**PLAN COMMISSION
MEETING NOTICE AND AGENDA
Thursday, June 18, 2026
6:00 PM**

Pewaukee City Hall Common Council Chambers
W240N3065 Pewaukee Road, Pewaukee, WI

To: File
From: Magdelene J. Wagner, P.E.
Subject: Williams Residence – N27W27136 Woodland Drive
Mitigation Plan
Date: June 8, 2026

Date: May 28, 2026
To: Cold Noses Sanctuary Property LLC
From: Nick Fuchs, Planner & Community Development Director
RE: Staff Comments - Site & Building Plan Review

PLAN TITLE:
**SITE AND
EROSION
CONTROL
DETAILS**

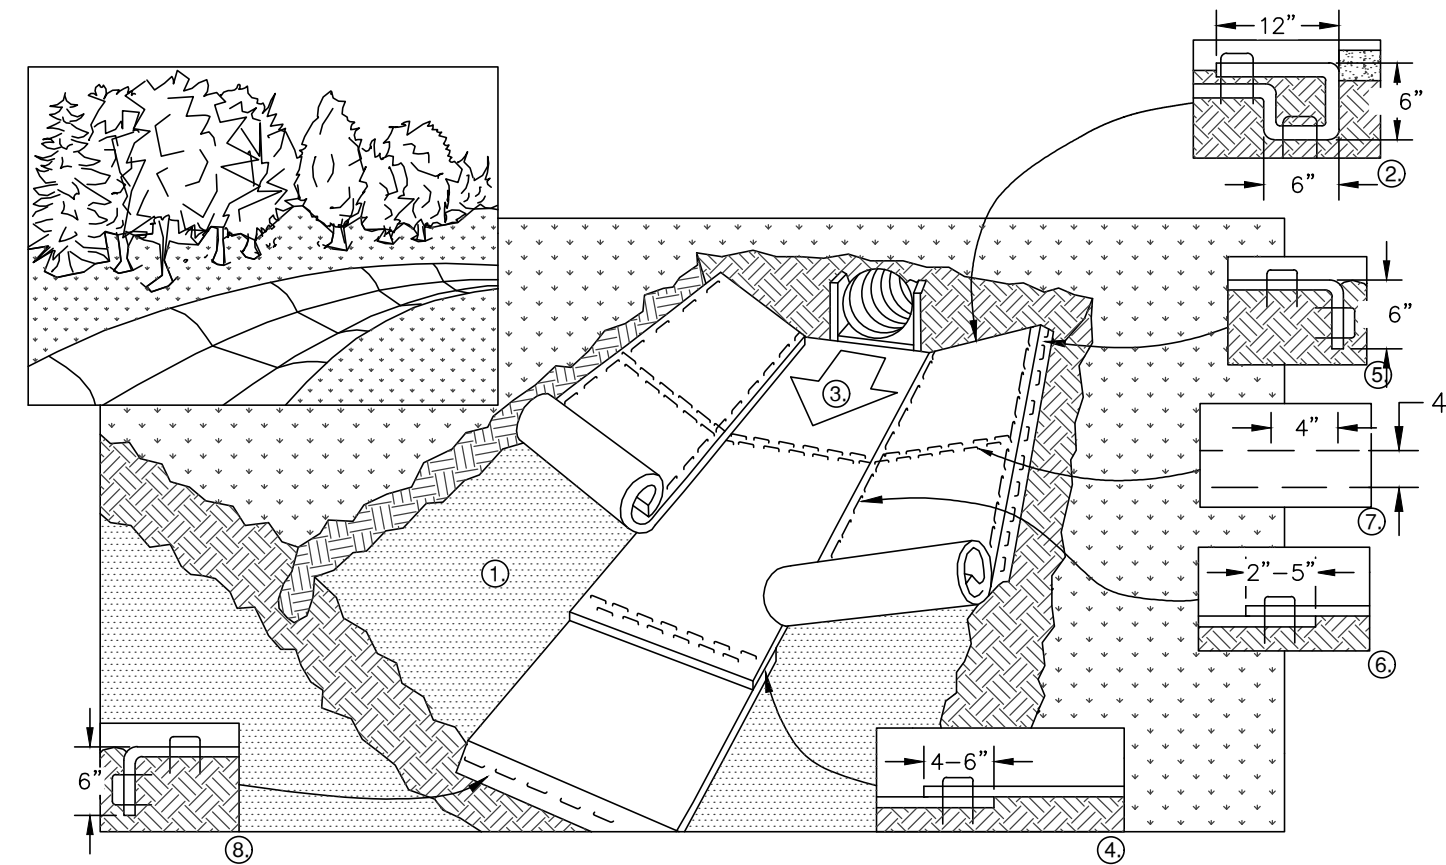
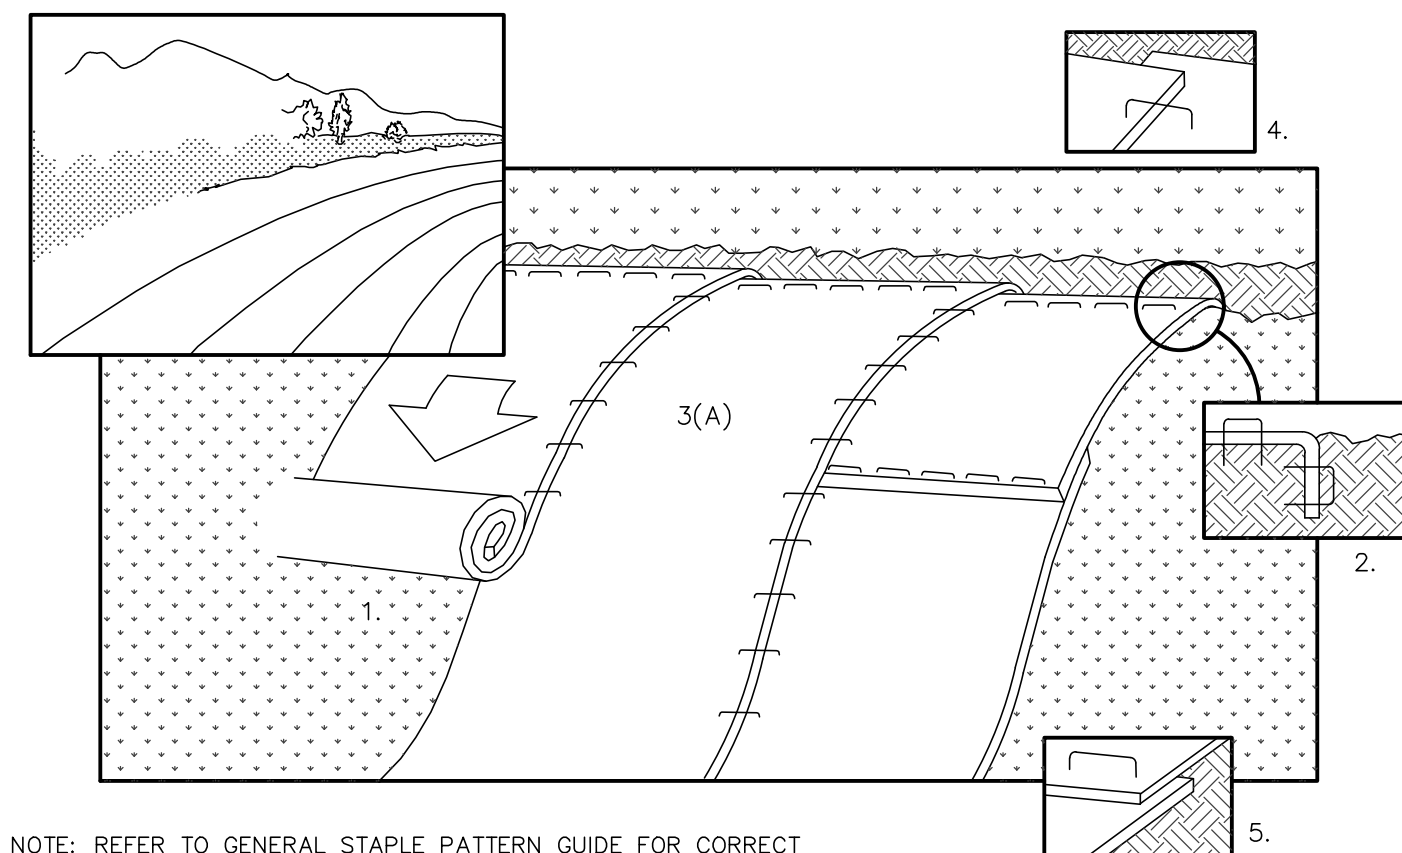
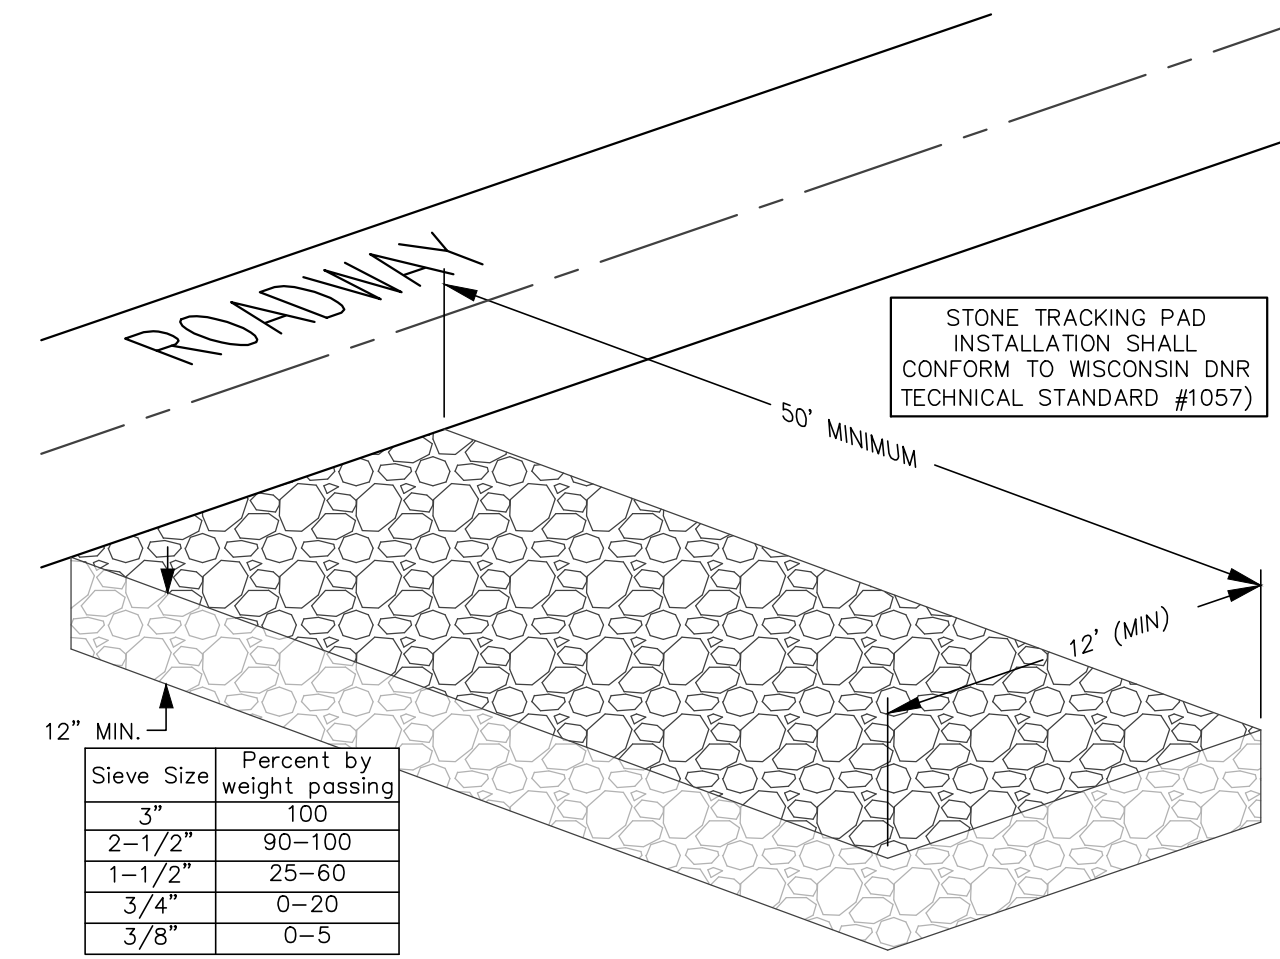
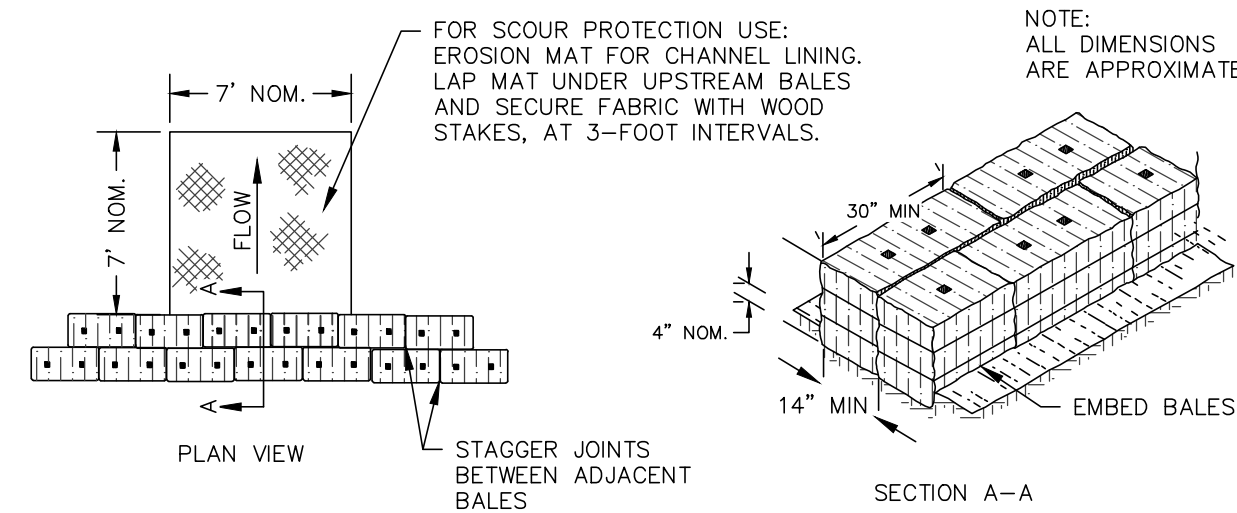
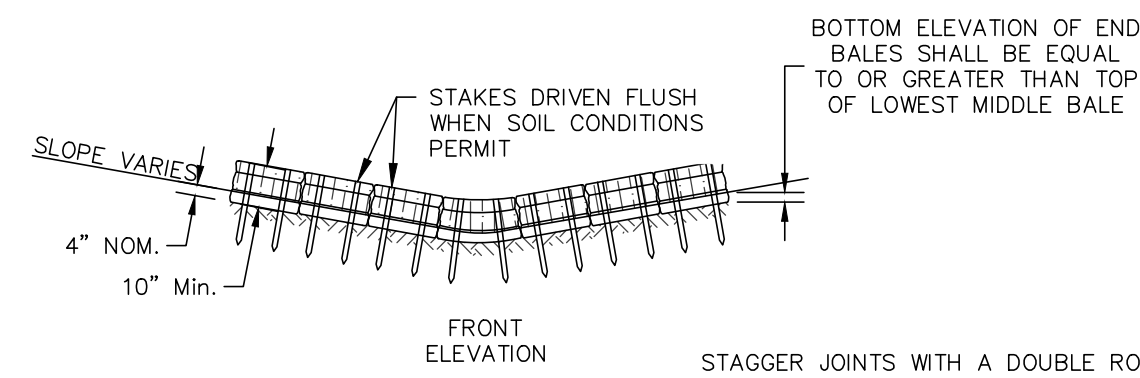
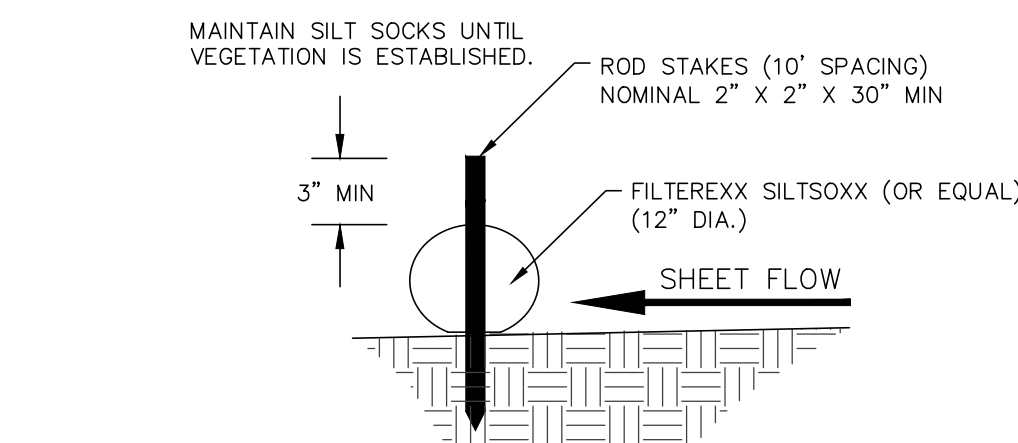
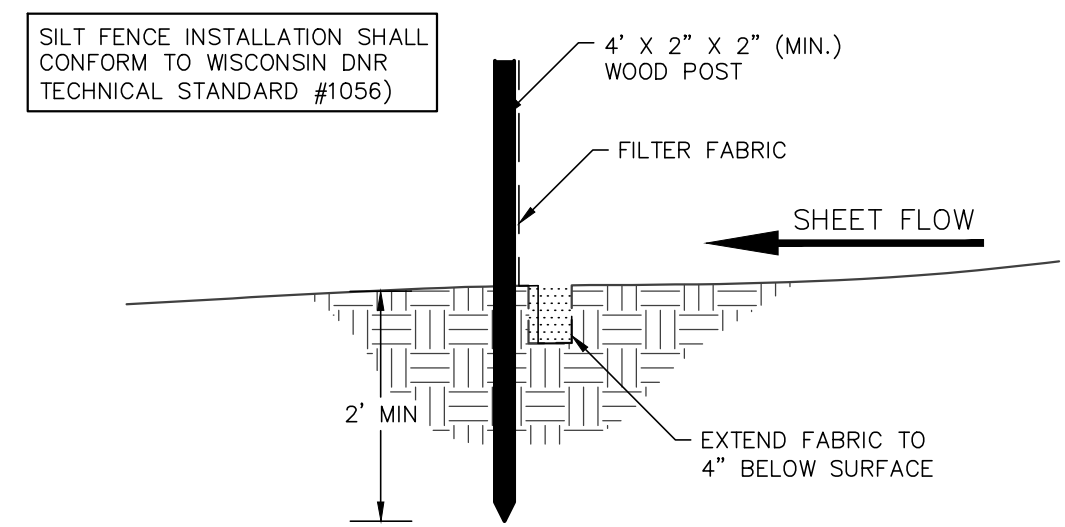
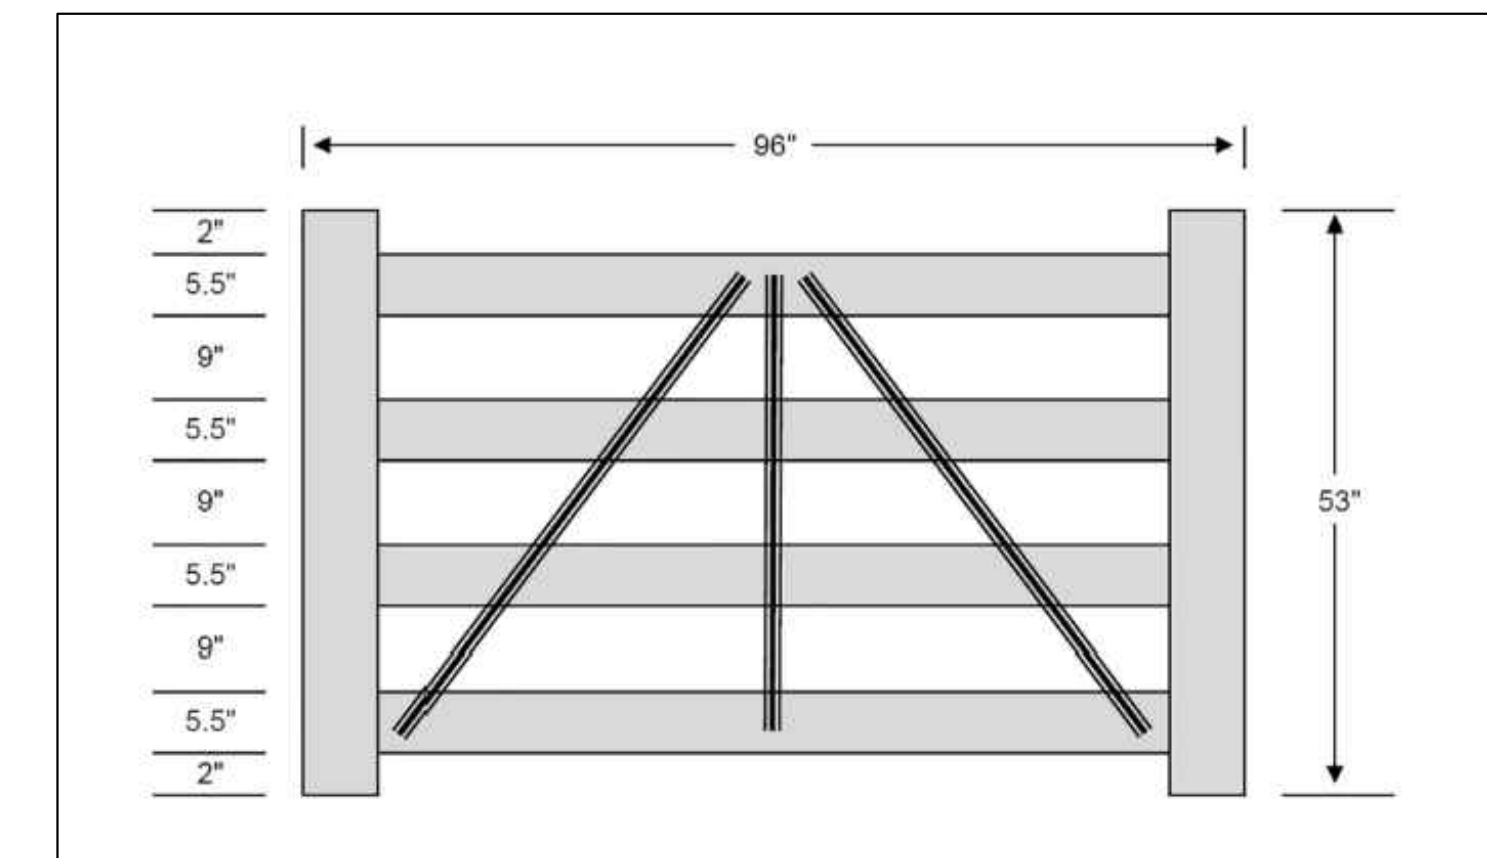
2. What is the height of the proposed fence? What is the style of the fence? It is recommended that a cut sheet or sample photo be provided of all proposed fencing. Note it is preferred that fencing located within the floodplain be an open style fence so not to catch debris or act as an obstruction during a flood event.

8. Please provide cut sheets for any proposed lighting. Note that the peak height of light poles and fixtures shall not exceed 20-feet. **Provided**
9. Staff recommends noting on the plans that the Feline Building was approved at the May 21, 2026, Plan Commission meeting. This will indicate that that building and the architectural plans are not part of this application. **Notes have been added to all the plans regarding the Feline Building approval.**
